Responses to your commentsPicatinny - Site 78 ROD (UNCLASSIFIED)

**Comments and Responses on the Site 78 Draft Final Record of Decision for Groundwater and Surface Water
for U.S. Army Garrison Picatinny Arsenal, New Jersey
Site 78 (PICA 013), Groundwater & Surface Water
Picatinny Arsenal, Morris County, New Jersey
July 2010**

**Commenter: Environmental Protection Agency
Comments Dated: January 26, 2011**

Site 78 (PICA 013) – Trend Plots for Groundwater and Surface Water

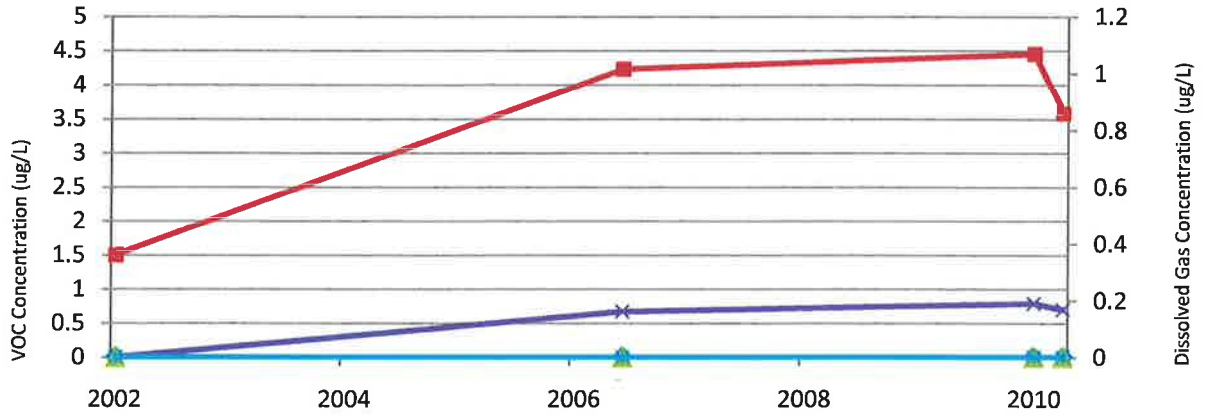
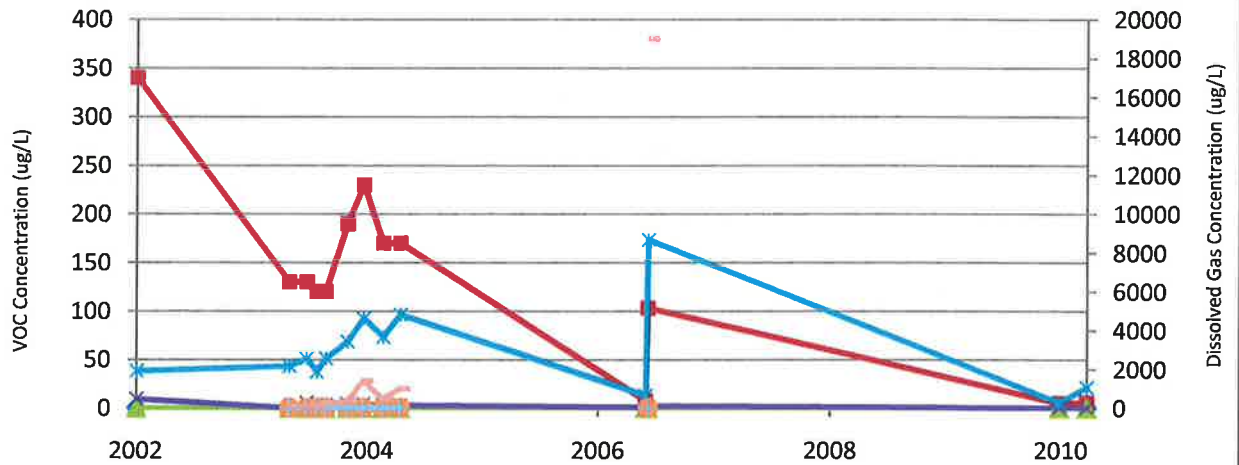
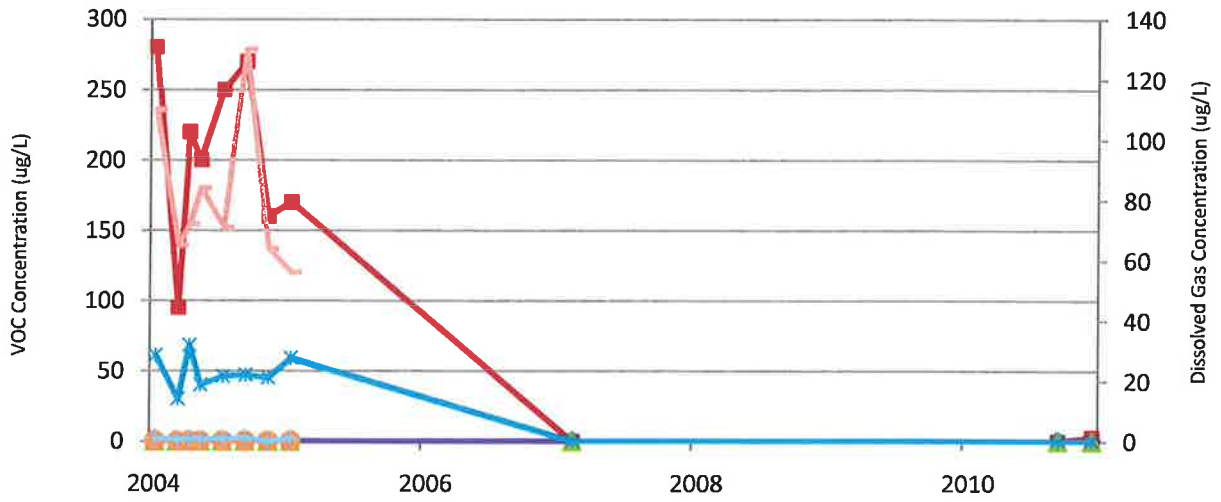
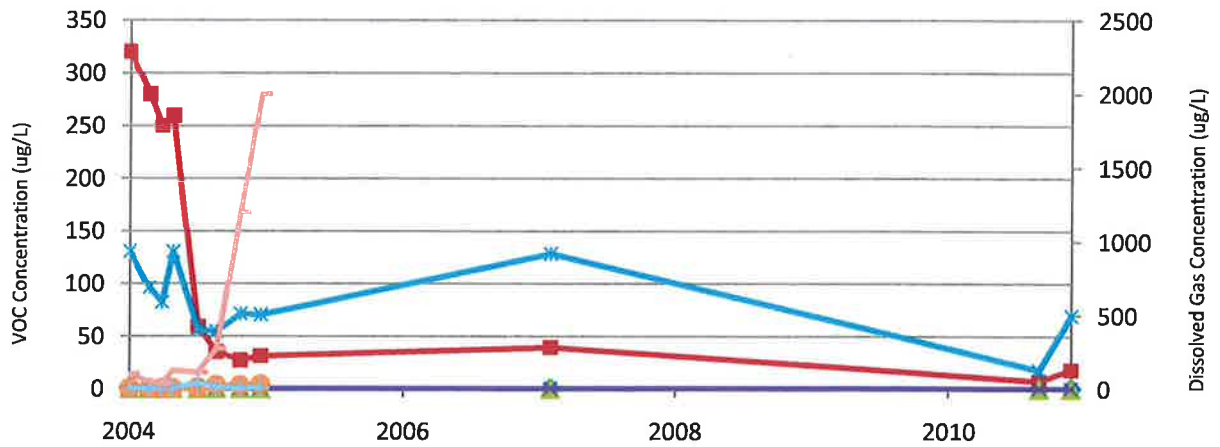
14.	Section 2.6.2, Summary and Findings of Site Investigations, Plume Delineation, page 2-5	Since the Army is basing its decision on selecting MNA as a remedy in part due the reduction of groundwater contaminants at Site 78, it is requested that a figure be added that shows the results of the 2007 sampling event.	<p><i>Comment noted. Figures 3 and 4 have been revised to include more recent data collected in 2010. Additionally, trend plots have also been added.</i></p>
